PLUG AND ABANDON WELLBORE
ROSS DRAW 25 FEDERAL COM 001
EDDY COUNTY, NEW MEXICO
Class II

Ross Draw 25 Federal Com 001 - Proposed WBD

Downhole Well Profile - with Schematic

Sundry ID 2696442

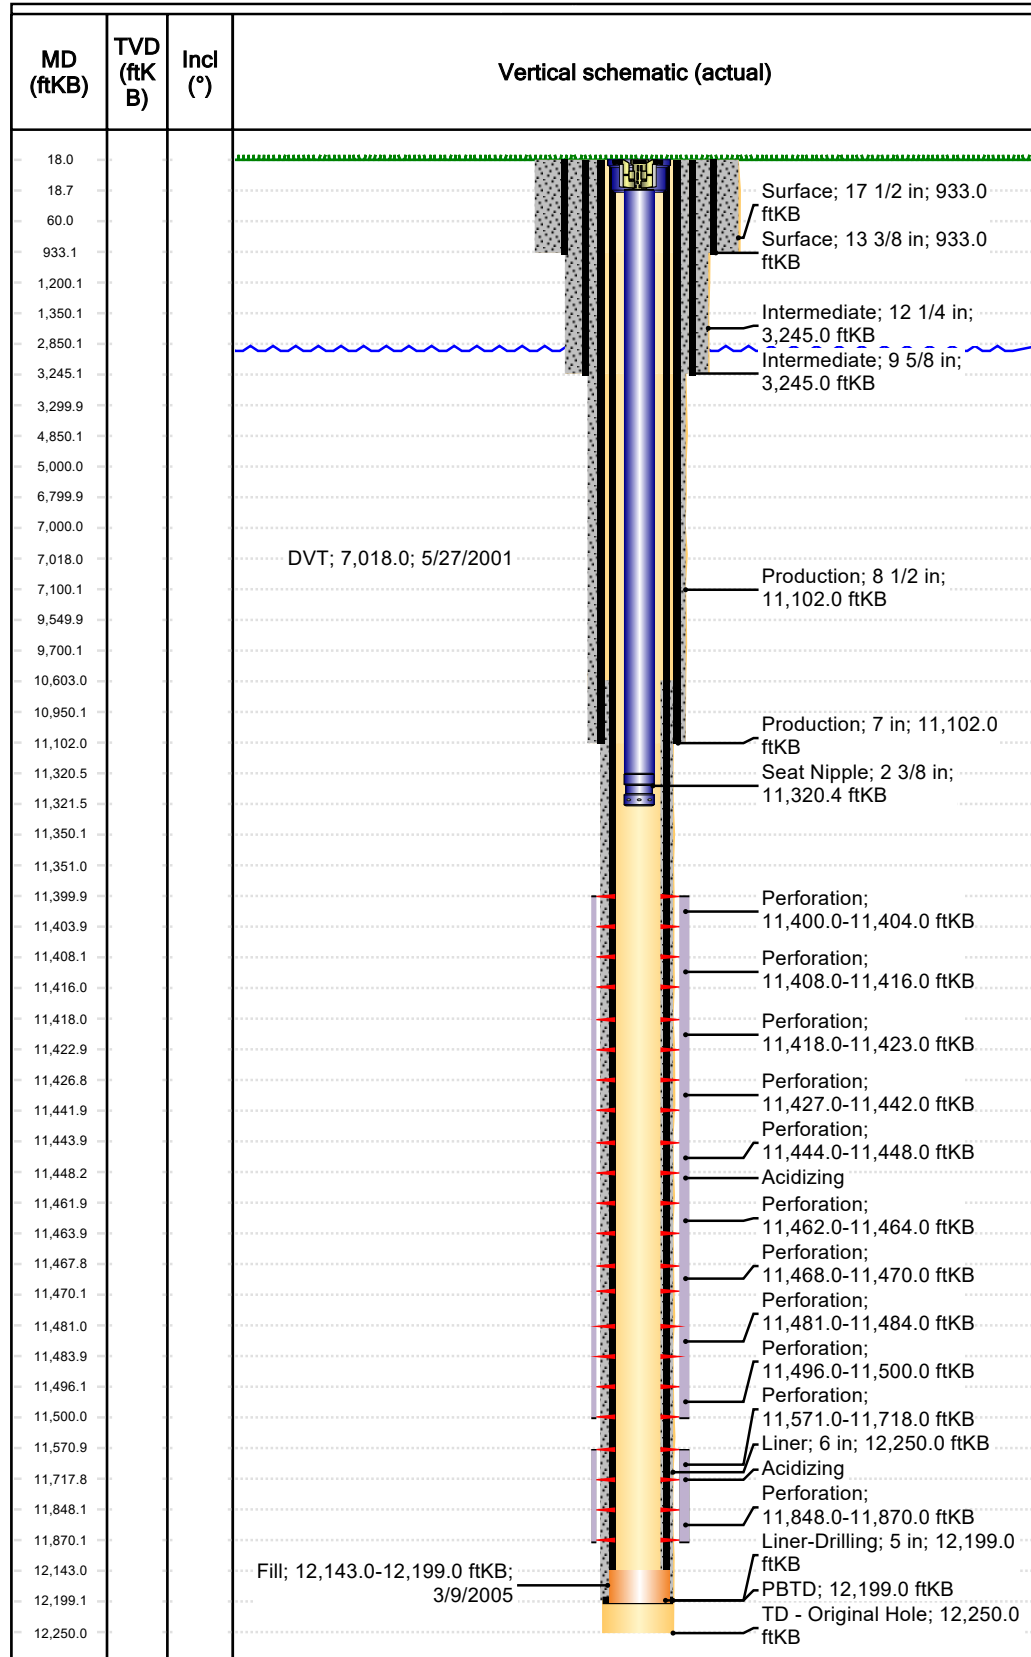
Bridge Plug - Permanent; 11,325.0-11,326.0

Squeeze ~15 SKS Class C: 100' to surface.

Squeeze 25 SKS Class C: 983' – 833'.
WOC and tag.

Squeeze 50 SKS Class C: 3300' – 3000'.
WOC and tag.

Squeeze 25 SKS Class C: 5000' – 4850'.

Squeeze 50 SKS Class C: 7070' – 6770'.
WOC and tag.

Squeeze 30 SKS Class H: 9680' – 9530'.

Spot 32 SKS Class H atop CIBP:
11325' – 11000'. Pressure test CIBP
to 500 psig for 30 min. WOC and tag.

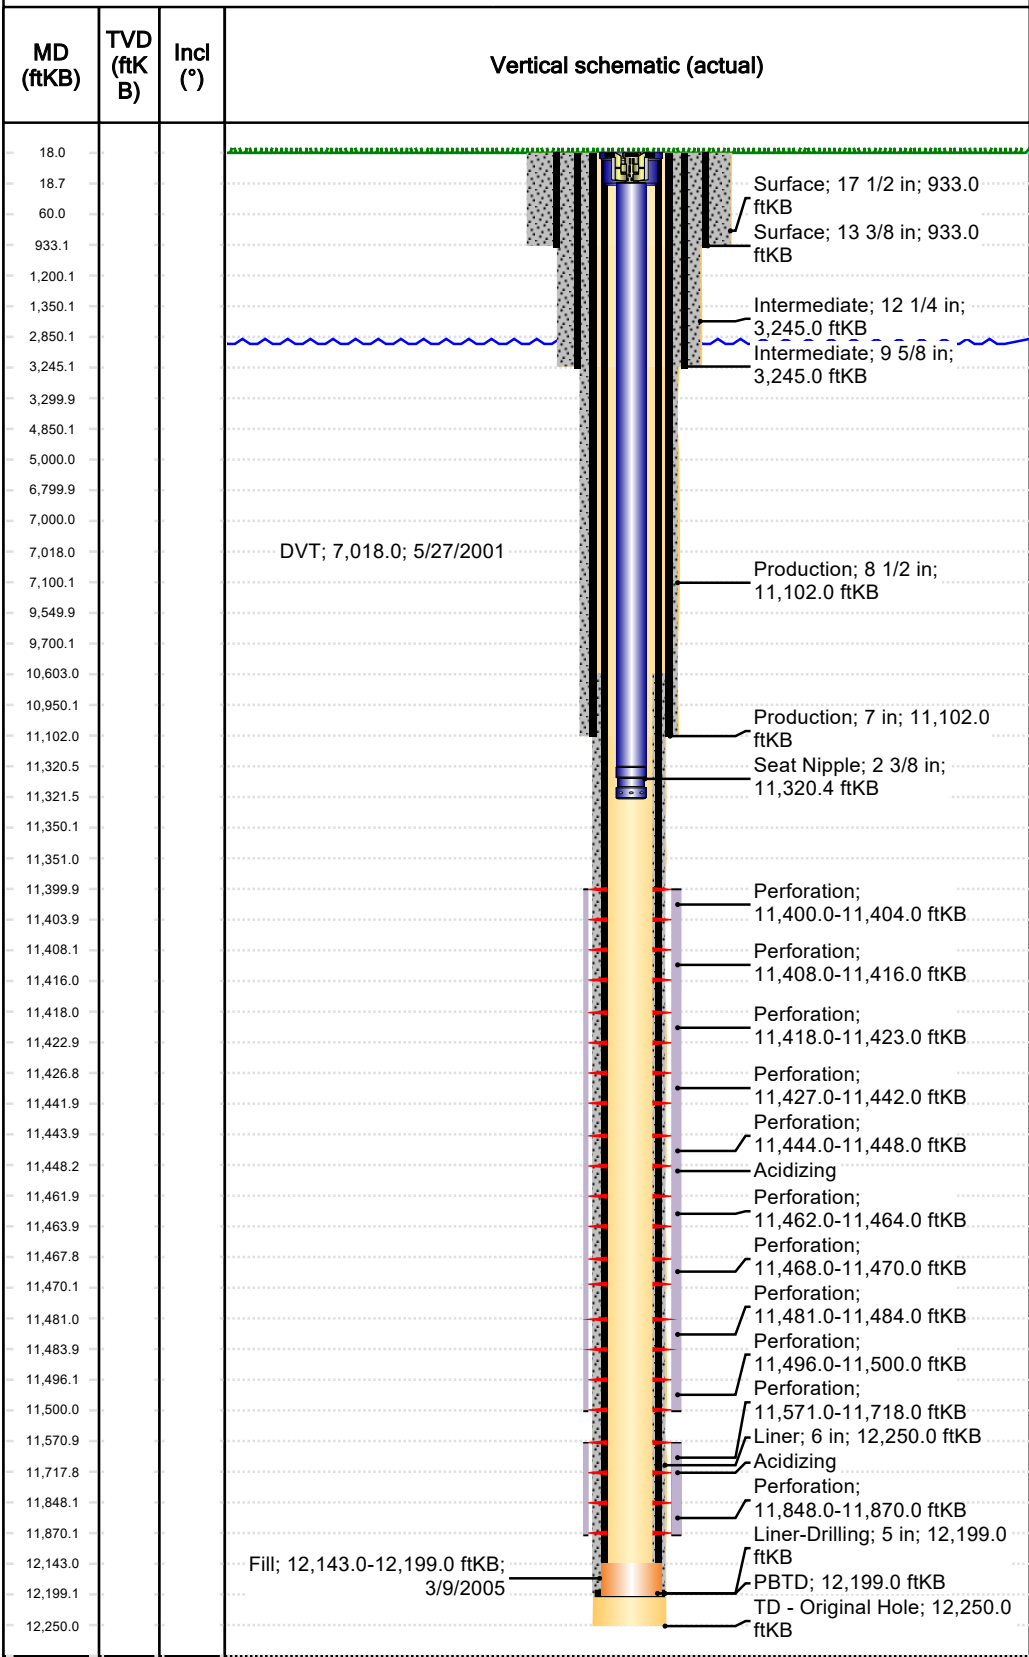
Plug Type	Top	Bottom	Length	Tag	Sacks	Notes
Surface Plug	0.00	983.00	983.00	Tag/Verify		
Fresh Water @ 350	296.50	400.00	103.50	If solid base no need to Tag (CIBP present and/or Mechanical Integrity Test), If Perf & Sqz then Tag, Leak Test all CIBP if no Open Perforations		
Top of Salt @ 788	730.12	838.00	107.88	Tag/Verify		
Shoe Plug	873.67	983.00	109.33	Tag/Verify	156.00	Spot cement from 983' to surface. Verify at surface
Base of Salt @ 1340	1276.60	1390.00	113.40	Tag/Verify	25.00	Spot cement from 1390' to 1276'. WOC and Tag. Class C
Delaware @ 3110	3028.90	3160.00	131.10	If solid base no need to Tag (CIBP present and/or Mechanical Integrity Test), If Perf & Sqz then Tag, Leak Test all CIBP if no Open Perforations

Spot cement from 3300' to 3000'. WOC and Tag. Class C
Shoe Plug	3162.55	3295.00	132.45	Tag/Verify	50.00	
				If solid base no need to Tag (CIBP present and/or Mechanical Integrity Test), If Perf & Sqz then Tag, Leak Test all CIBP if no Open Perforations		
Bonesprings @ 6870	6295.00	6920.00	625.00			
						Spot cement from 7070' to 6295'. Class C
DV tool plug	6897.82	7068.00	170.18	Tag/Verify	122.00	
				If solid base no need to Tag (CIBP present and/or Mechanical Integrity Test), If Perf & Sqz then Tag, Leak Test all CIBP if no Open Perforations		
Wolfcamp @ 9622	9475.78	9672.00	196.22		41.00	Spot cement from 9680' to 9475'. Class H
Liner Top @ 10603	10446.97	10653.00	206.03	base no		
Shoe Plug	10940.98	11152.00	211.02	Tag/Verify

If solid base no need to Tag (CIBP present and/or Mechanical Integrity Test), If Perf & Sqz then Tag, Leak Test all CIBP if no Open Perforations		
CIBP Plug	11290.00	11325.00	35.00		99.00	Set CIBP at 11325'. Spot cement from 11325' to 10446'. Class H. Leak Test CIBP. WOC and Tag. (68 sxs from 11325' to 10603', 31 sxs from 10603' to 10446')
Perforations Plug (If No CIBP)	11350.00	11920.00	570.00	Tag/Verify		
Shoe Plug	12077.50	12300.00	222.50	Tag/Verify
